13
13
1
13TH DECEMBER 1888, Nos. 552, 553, MARINE.

MARINE DEPARTMENT.

Cyclone Code.

Making an addition to the revised — regarding
storm signals and forwarding copy of these Pro-
ceedings to the Government of India.

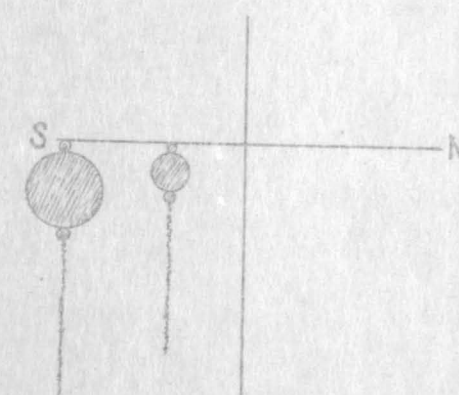
The experience gained during the recent cyclone points to the necessity of a slight addition to the storm signals in order to make it clear to the commanders of vessels and others as to the direction of the storm; I therefore have the honor to submit, for approval, the necessary additions, which, I consider, will afford the information required. I have also included in my proposal a signal to be hoisted when it is considered necessary for vessels to leave the harbour without delay.

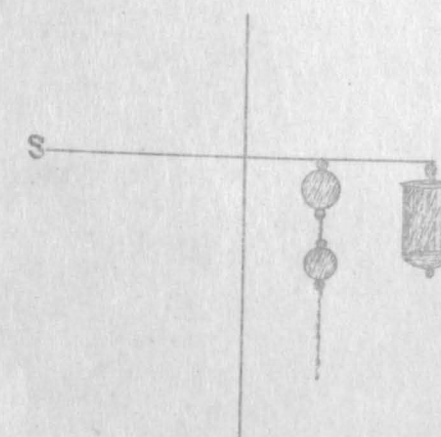
This signal would indicate that a storm of slight intensity had formed and was advancing towards the coast to the southward of the port.

This signal would indicate that a storm of considerable intensity would probably strike the coast to the north of the port.

(1) The warning and danger signals, according as they are hoisted at the northern or southern arm of the yard of the Port Flagstaff, indicate that the storm is expected to strike the coast to the north or south of the port, and when hoisted at the mast head of the flagstaff that the centre of the storm is expected to pass over the port.

(2) The intensity of the storm will be indicated during daylight by additional balls of a size half the diameter of the ball used as a warning signal, hoisted to the same yard-arm as the warning or danger signal, but between it and the flagstaff; thus, one small ball will indicate a storm of slight intensity, two small balls a storm of considerable intensity.

The following "Note" will be added to and read as part of section 6, chapter I of the revised Cyclone Code issued in G.O., dated 23rd October 1888, No. 494 :—

Signal to leave the harbour at once.

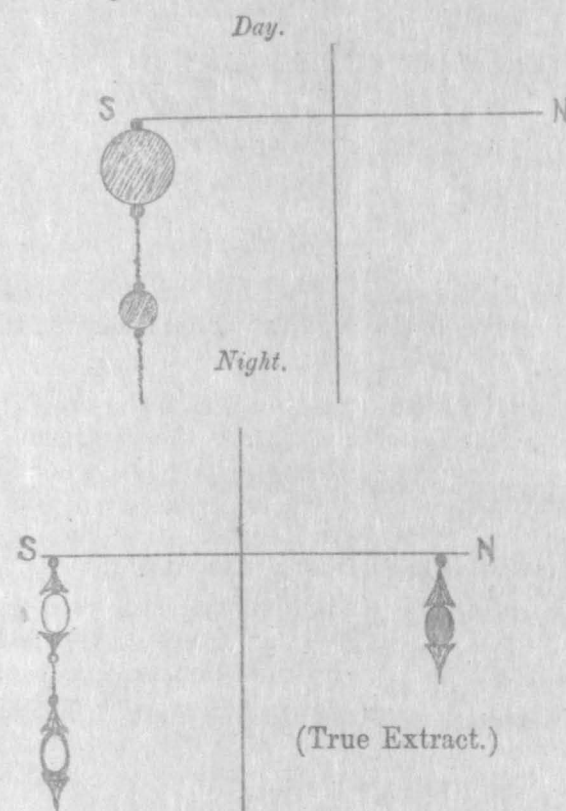
(3) A small ball hoisted under the day warning or danger signals and a red light at night at the opposite yard-arm to that at which the warning or danger signal may be displayed will indicate that vessels are to leave the harbour at once.

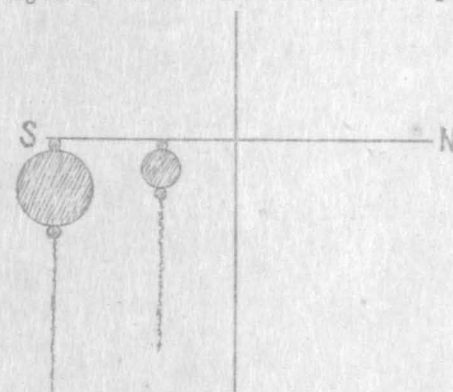
The experience gained during the recent cyclone points to the necessity of a slight
addition to the storm signals in order to make it clear to the commanders of vessels
and others as to the direction of the storm; I therefore have the honor to submit, for
approval, the necessary additions, which, I consider, will afford the information
required. I have also included in my proposal a signal to be hoisted when it is
considered necessary for vessels to leave the harbour without delay.

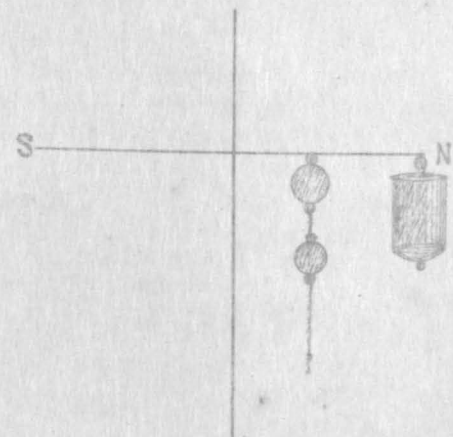
This signal would indicate that a storm of slight intensity had formed and was advanc-
ing towards the coast to the southward of the port.

(1) The warning
and danger signals,
according as they are
hoisted at the northern
or southern arm of
the yard of the Port
Flagstaff, indicate that
the storm is expected
to strike the coast to
the north or south of
the port, and when
hoisted at the mast
head of the flagstaff
that the centre of the
storm is expected to
pass over the port.

This signal would indicate that a storm of considerable intensity would probably strike
the coast to the north of the port.

(2) The intensity
of the storm will be
indicated during day-
light by additional balls
of a size half the dia-
meter of the ball used
as a warning signal,
hoisted to the same
yard-arm as the warn-
ing or danger signal,
but between it and the
flagstaff; thus, one
small ball will indicate
a storm of slight inten-
sity, two small balls a
storm of considerable
intensity.

The following "Note" will be added to and read as part of section 6, chapter I
of the revised Cyclone Code issued in G.O., dated 23rd October 1888, No. 494:—

Signal to leave the harbour at once.

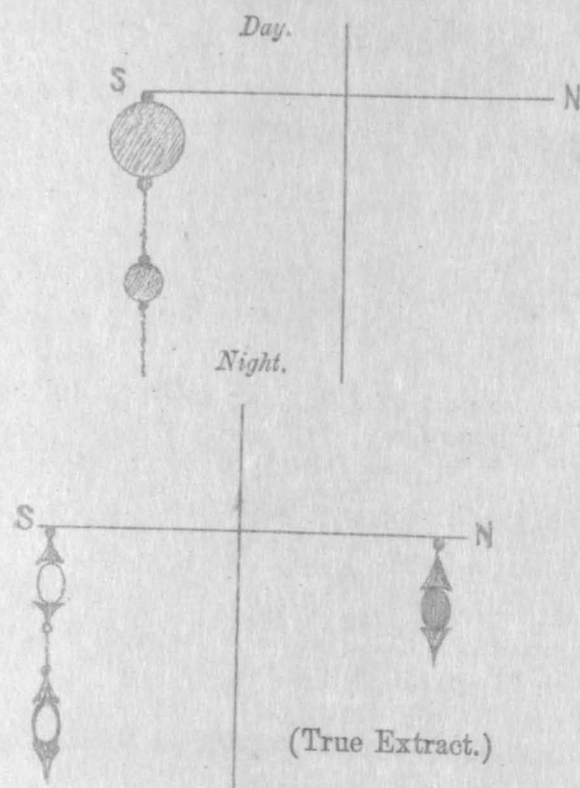
(3) A small ball hoisted under the day warning or danger signals and a red light at night at the opposite yard-arm to that at which the warning or danger signal may be displayed will indicate that vessels are to leave the harbour at once.
